SUBJECT: NuScale Power, LLC Response to NRC Request for Additional Information No. 17 (eRAI No. 8767) on the NuScale Design Certification Application

Enclosure 1: NuScale Response to NRC Request for Additional Information eRAI No. 8767

NRC Question No.: 15.06.06-1

Figure 15.6-67: Inadvertent Operation of an Emergency Core Cooling System Valve – Critical Heat Flux Ratio

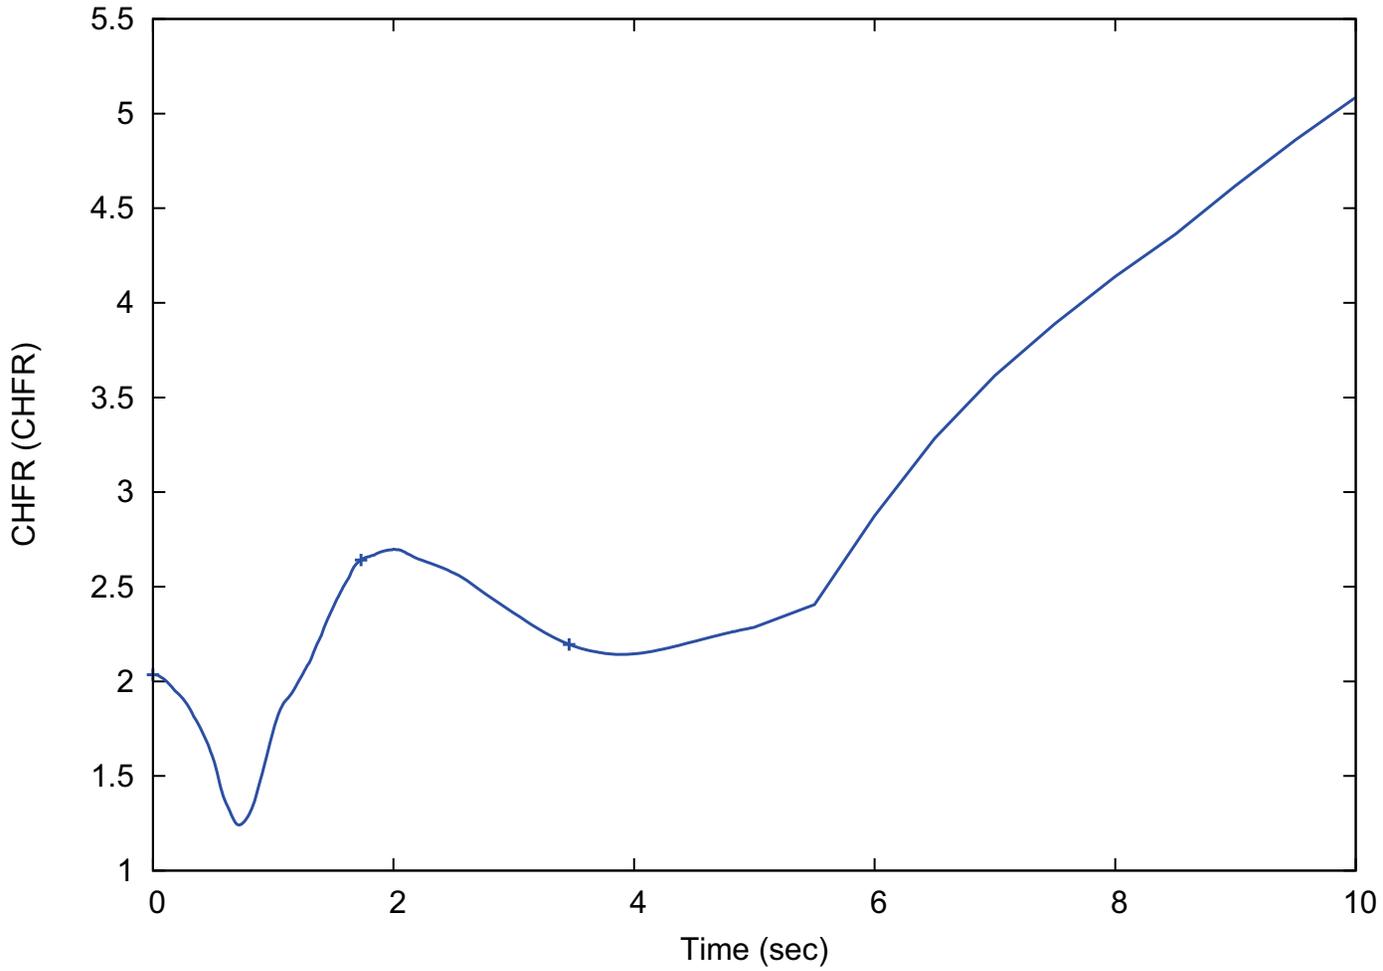
In FSAR Tier 2, Section 15.6.6, "Inadvertent Operation of Emergency Core Cooling System," the applicant does not provide a plot of minimum critical heat flux ratio (MCHFR). In accordance with DSRS Section 15.6.6, Review Procedure 7, the staff cannot determine if the MCHFR is acceptable for this event. The staff recognizes that the MCHFR is reported in FSAR Tier 2, Section 15.6.6.6, "Conclusions." However, this does not allow the staff to assess the MCHFR throughout the transient to verify when and where the MCHFR occurs. Based on the docketed information, the staff cannot determine if abundant core cooling is provided during the accident and will prevent fuel and clad damage that could interfere with continued effective core cooling. The staff requests the applicant to provide additional plots in the FSAR of MCHFR for the entire transient ("zoomed-in" and "zoomed-out") that show how the MCHFR behaves as the transient progresses.

A plot of the "zoomed-in" critical heat flux ratio (CHFR) has been added to FSAR Section 15.6.6 as FSAR Figure 15.6-67 and a "zoomed-out" CHFR plot has been added as FSAR Figure 15.6-68. FSAR Figure 15.6-67 confirms that the minimum CHFR (MCHFR) is 1.240 and that MCHFR occurs shortly, within one second, after event initiation, as reported in FSAR Section 15.6.6.5. FSAR Section 15.6.6.5 states that the MCHFR is above the CHFR limit. Figure 15.6-68 provides CHFR for the duration of the event.

As stated in FSAR Section 15.6.6.3.1, due to the phenomenological similarities between an inadvertent opening of an ECCS valve and a LOCA, the LOCA evaluation model is conservatively used to evaluate the inadvertent opening of an ECCS valve event. Topical Report TR-0516-494422, Loss-of-Coolant Accident Evaluation Model, Section 4.3 discusses the figures of merit (FOM) for characterizing the plant accident response. The CHFR is an important FOM as it demonstrates there is no significant heatup of the cladding. The MCHFR is above the CHFR limit and occurs within one second of event initiation, therefore, there is no significant heatup of the cladding.

The fuel integrity is not challenged by the spurious opening of the RVV. The fuel temperatures decrease upon the reactor trip, as shown in Figure 15.6-65 and Figure 15.6-66, and the water level remains above the top of the active fuel, as shown in Figure 15.6-62. The MCHFR is 1.240, [as shown in Figure 15.6-67 and Figure 15.6-68](#), which is greater than the 95/95 limit of 1.122. As noted in Section 15.6.6.3.1, MCHFR occurs in the high flow correlation range shortly after event initiation as reactor power is still elevated at this time.
